ADDENDUM NO. 1

May 31, 2023

Noblesville Ambulatory Surgery Center
14065 Borg Warner Drive
Noblesville, IN 46060

C002

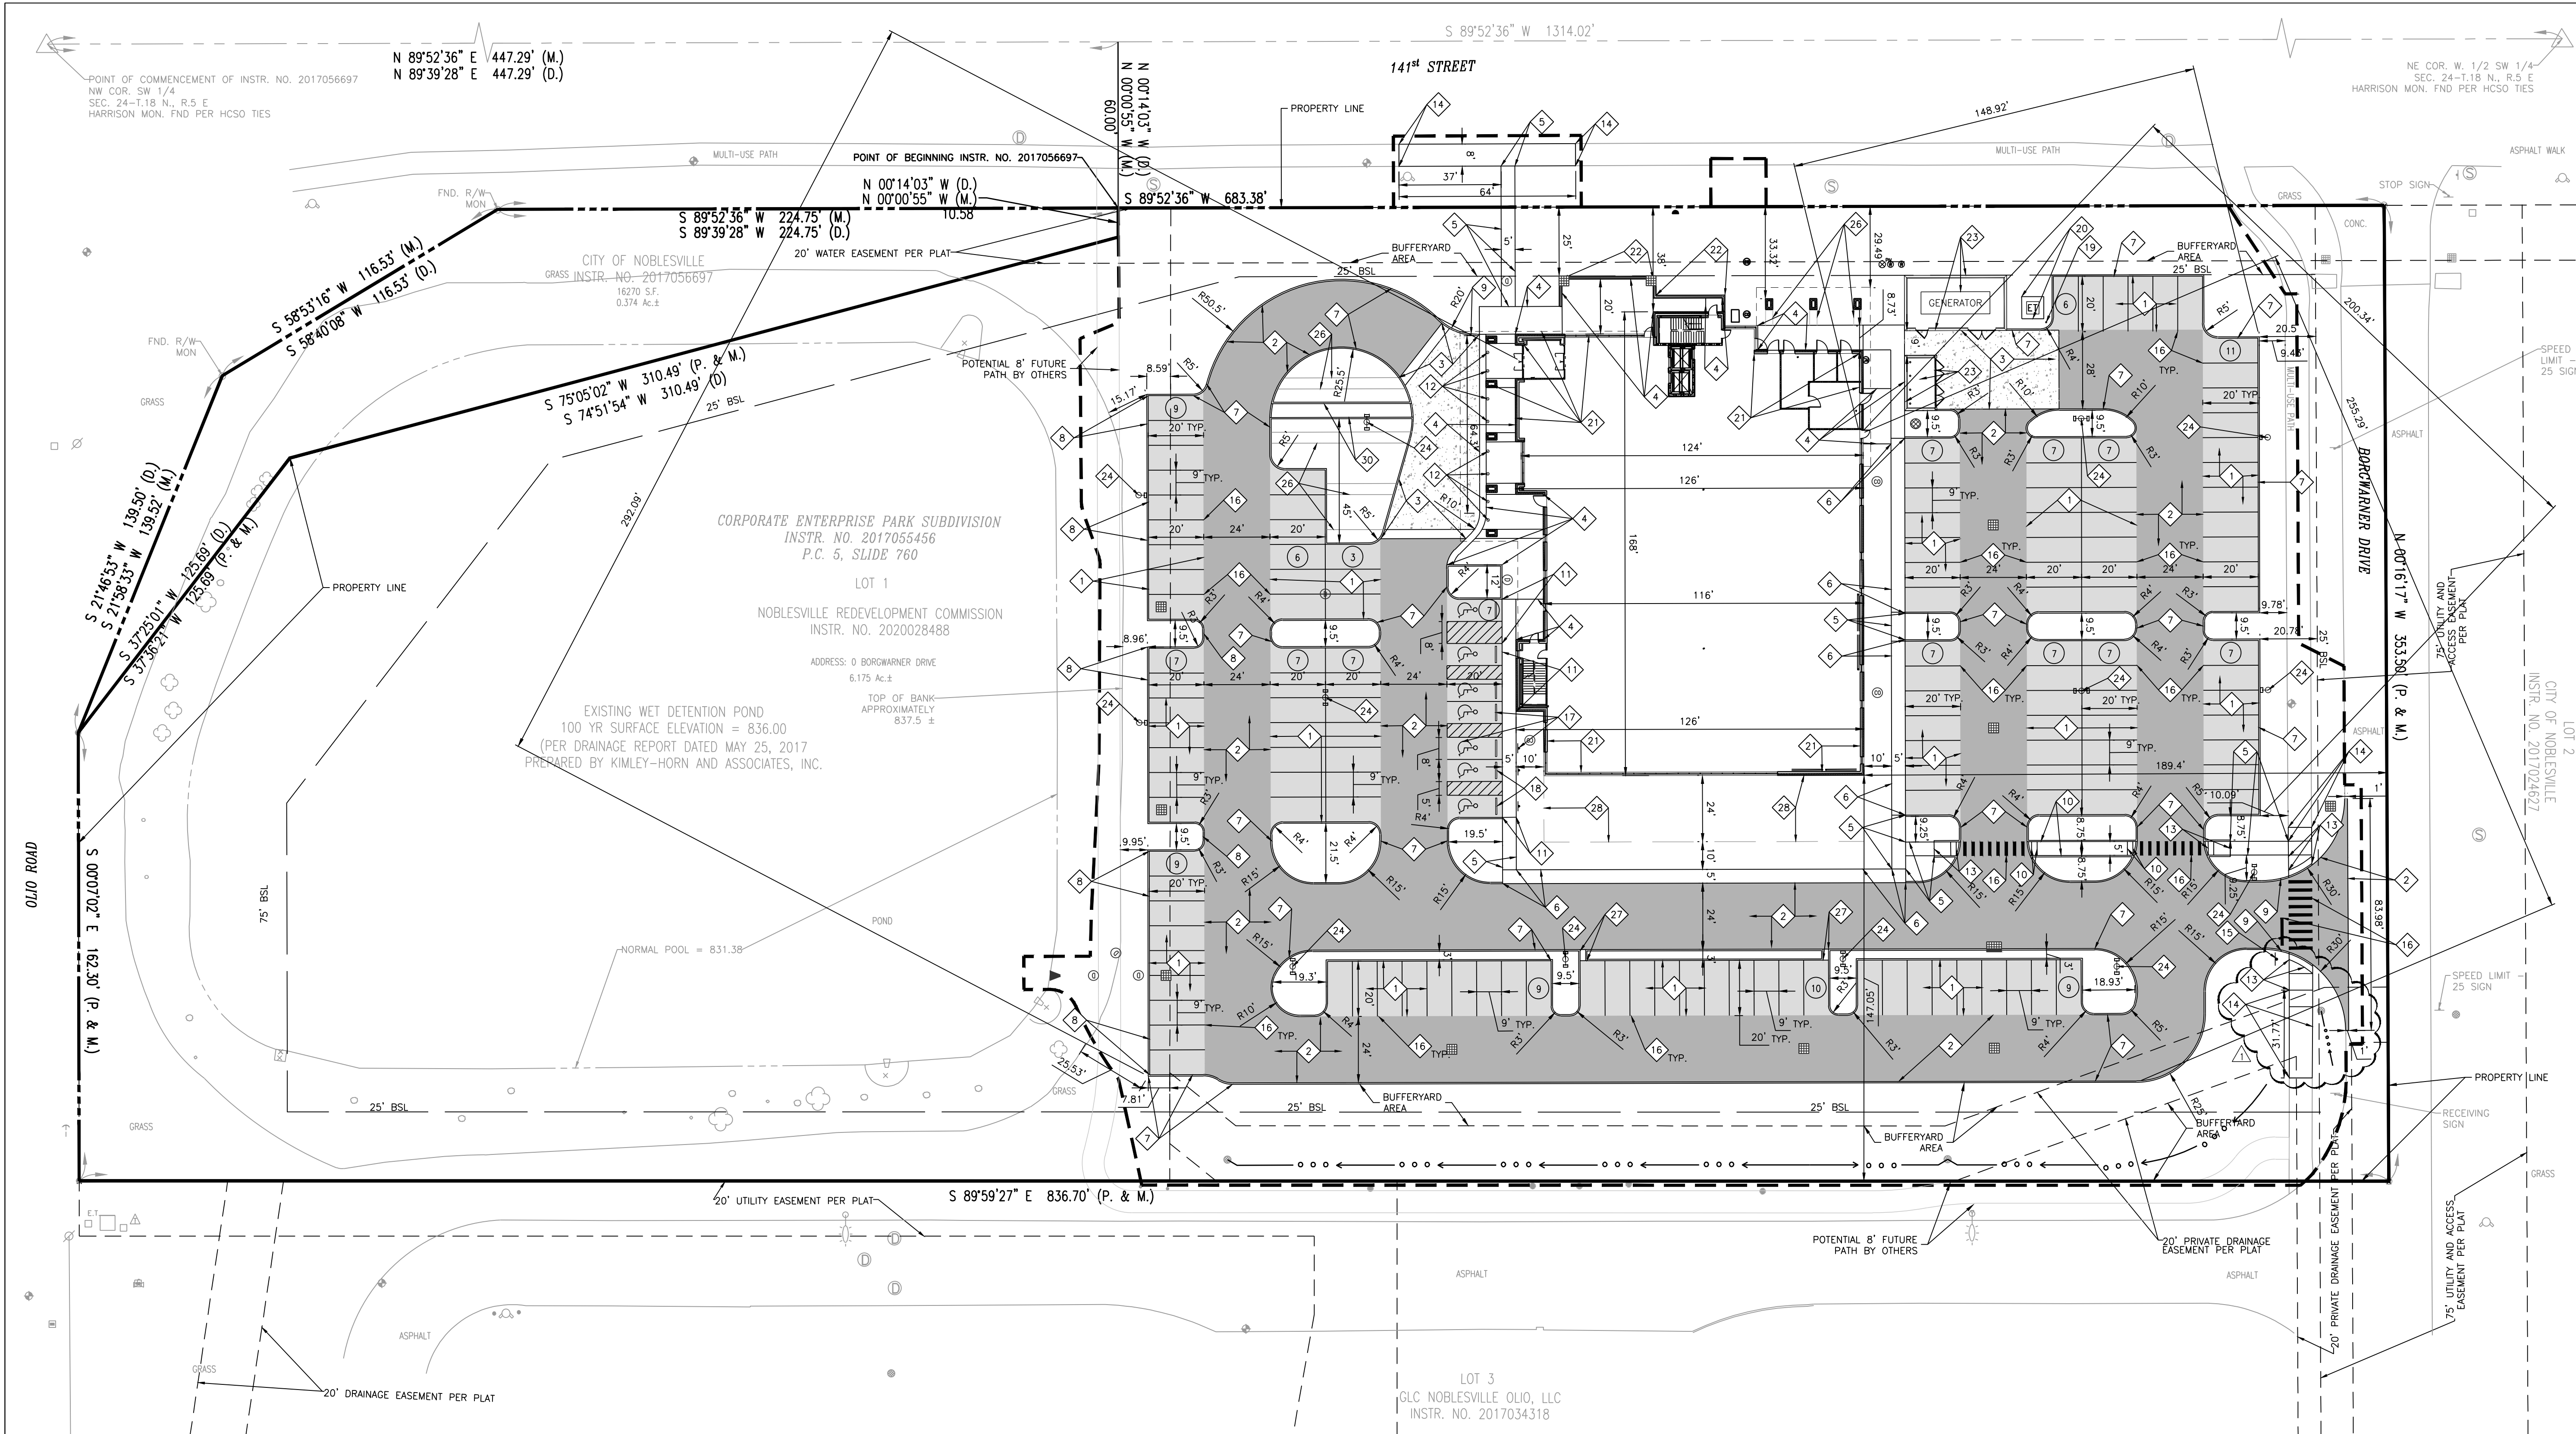
1. Issued for tracking purposes.
2. Added sheet C002 "Drainage Overflow Exhibit"

1. Added sheet in its entirety.

C201

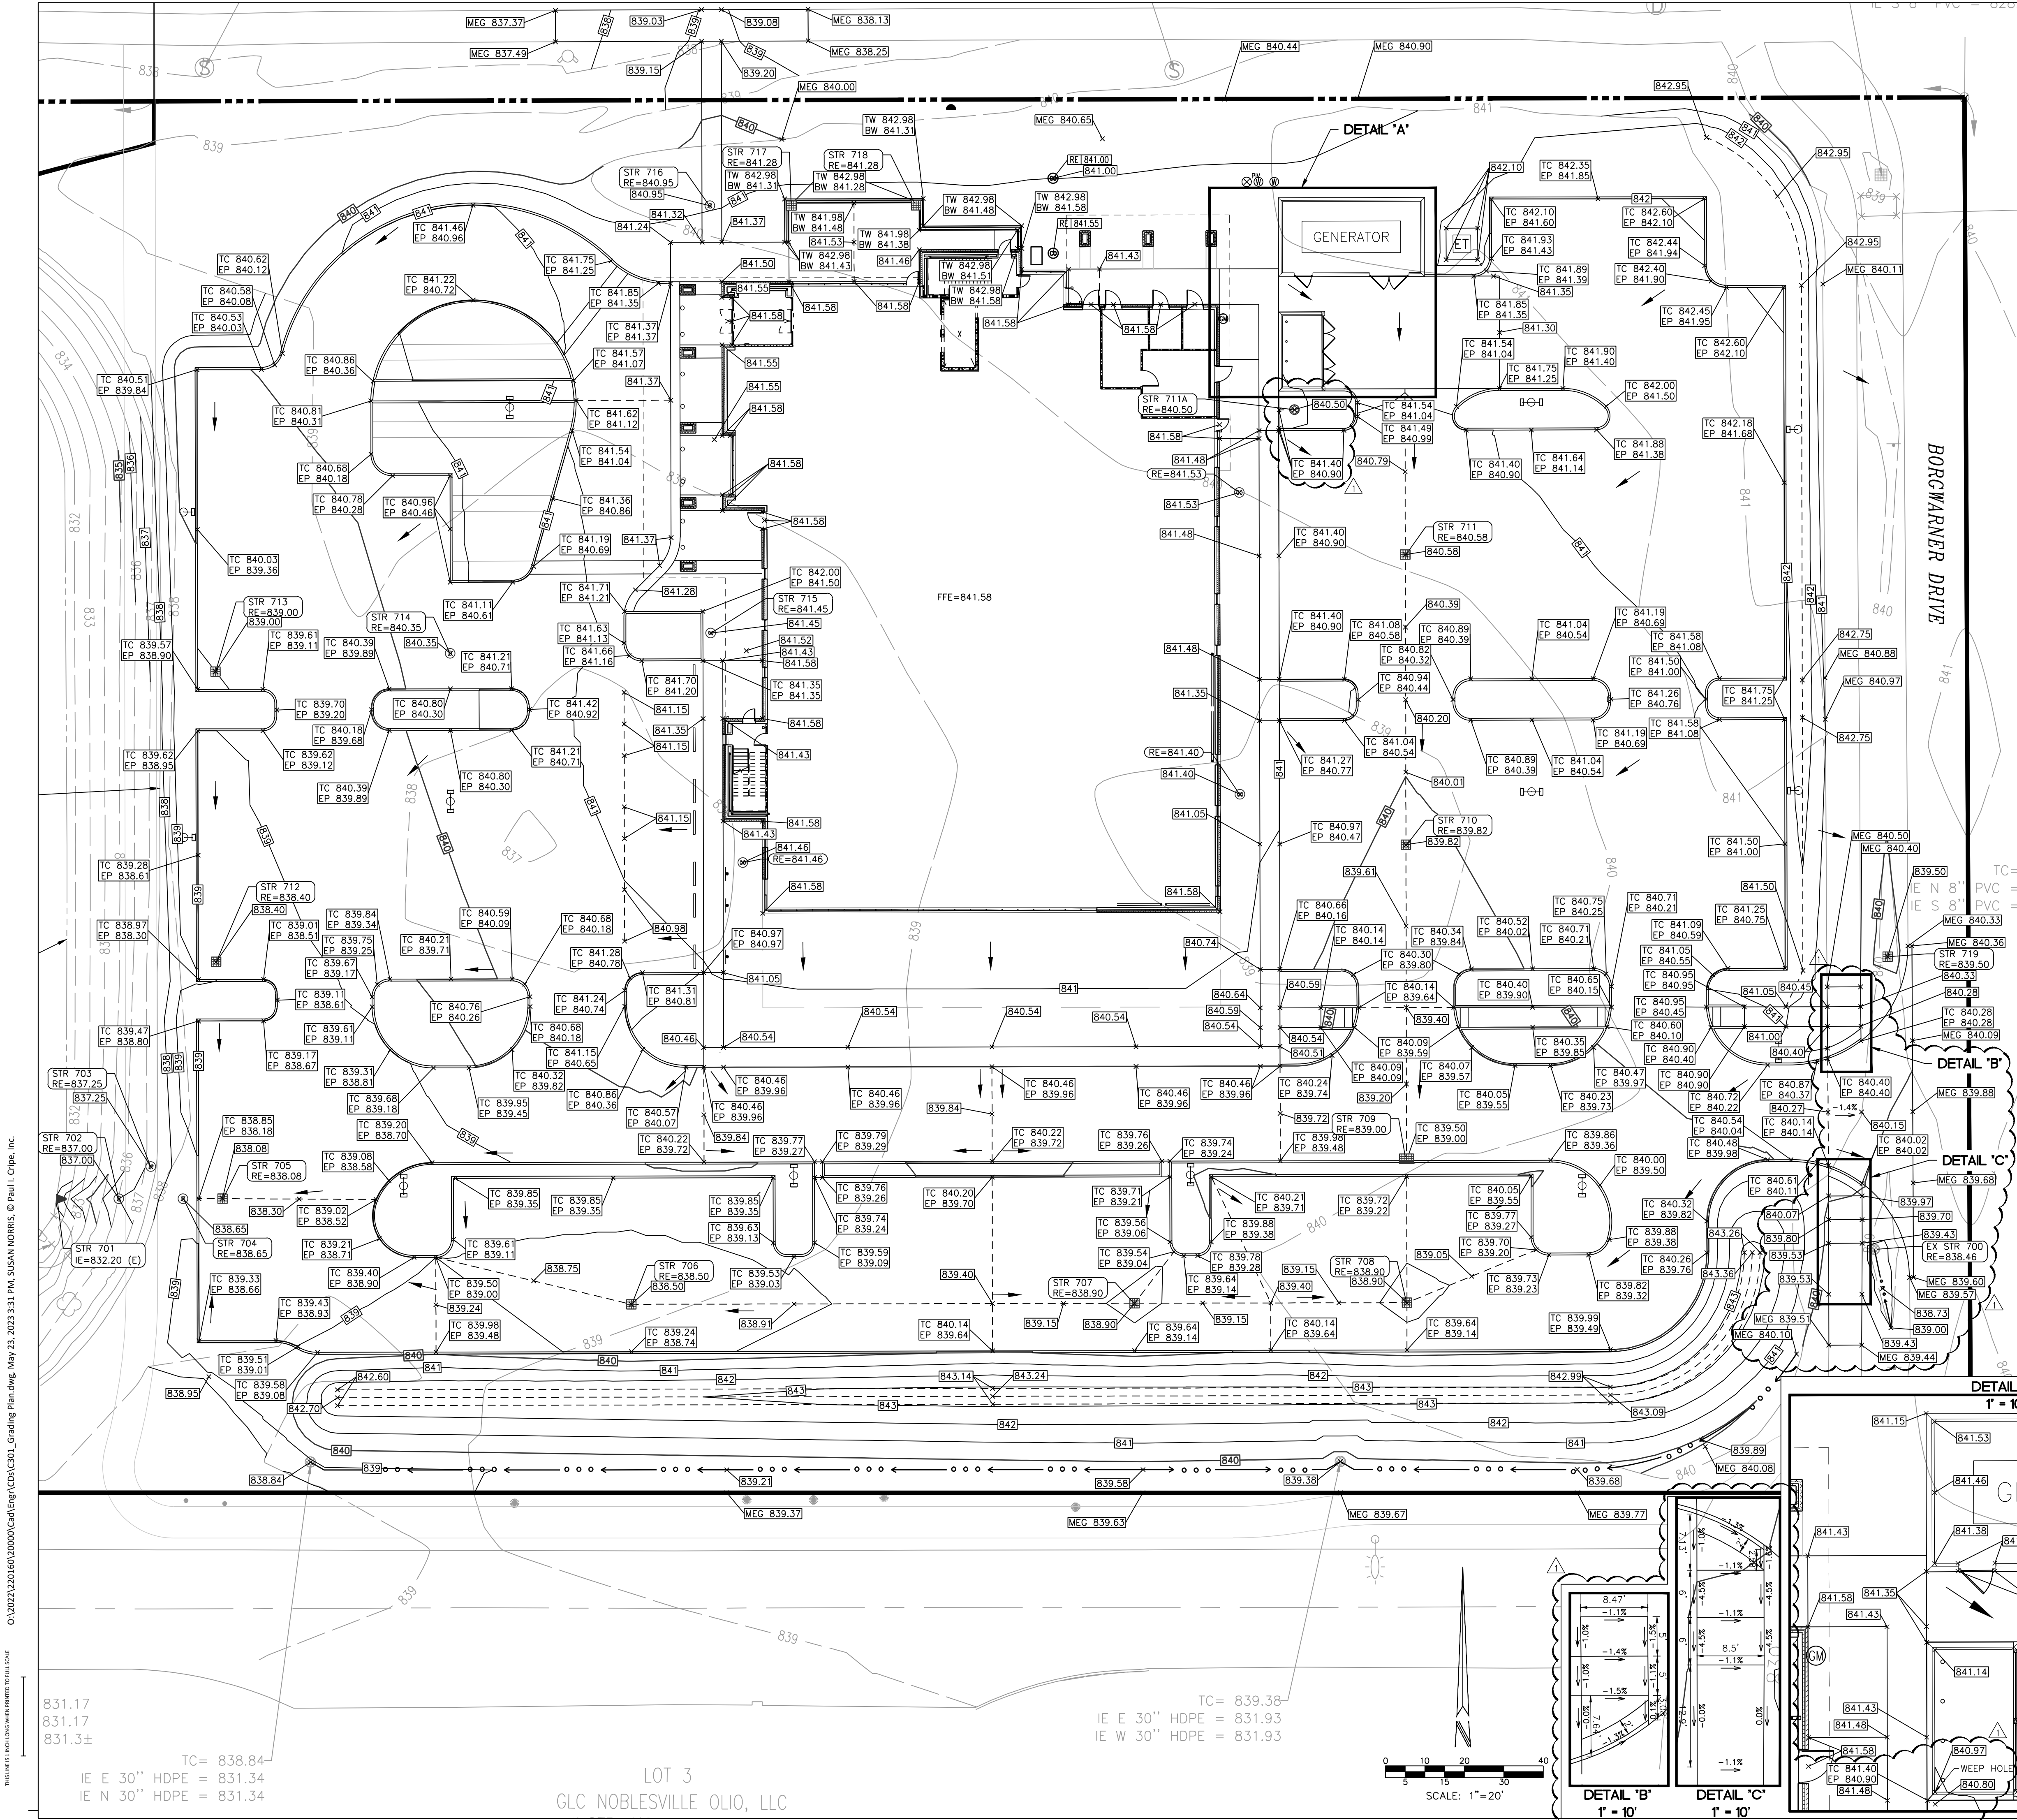
C201 – SITE PLAN

GRADING PLAN

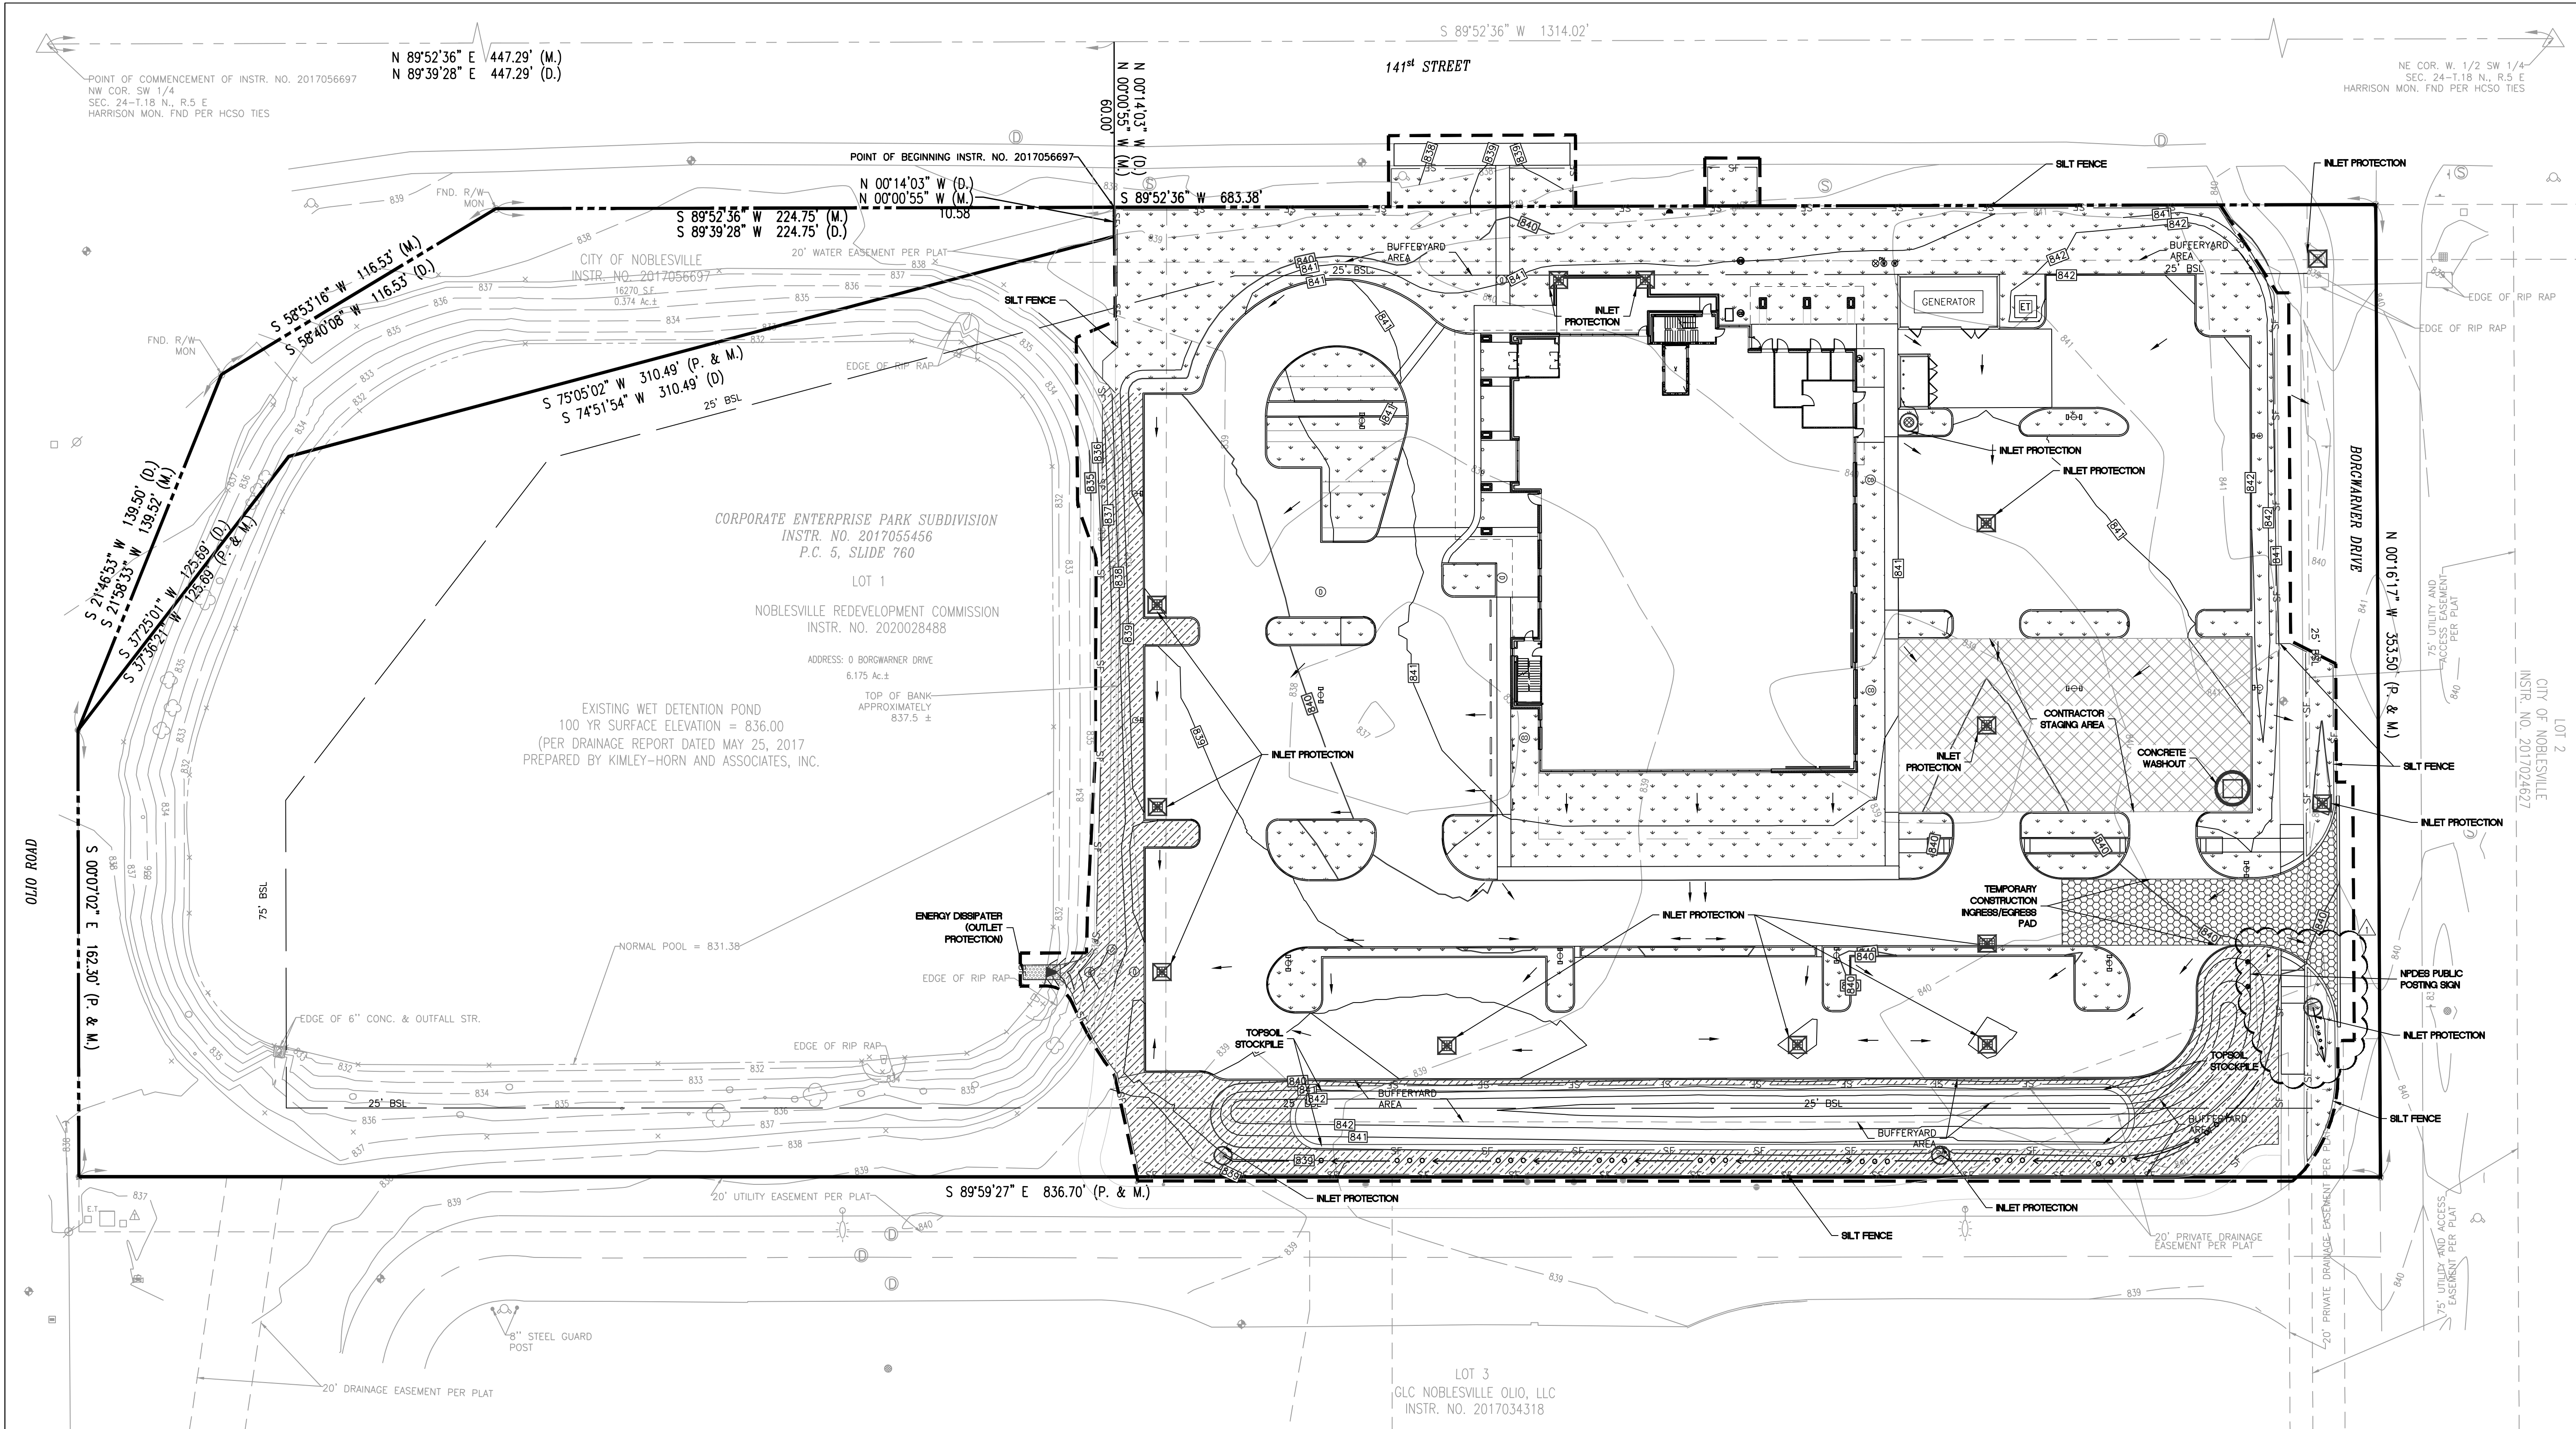
1. Extended proposed limits of asphalt path.
2. Updated grading of southern ramp to be ADA compliant
3. Added details B and C to show slopes and dimensions of ramps.
4. Added spots for clarification around dumpster enclosure's weep hole.
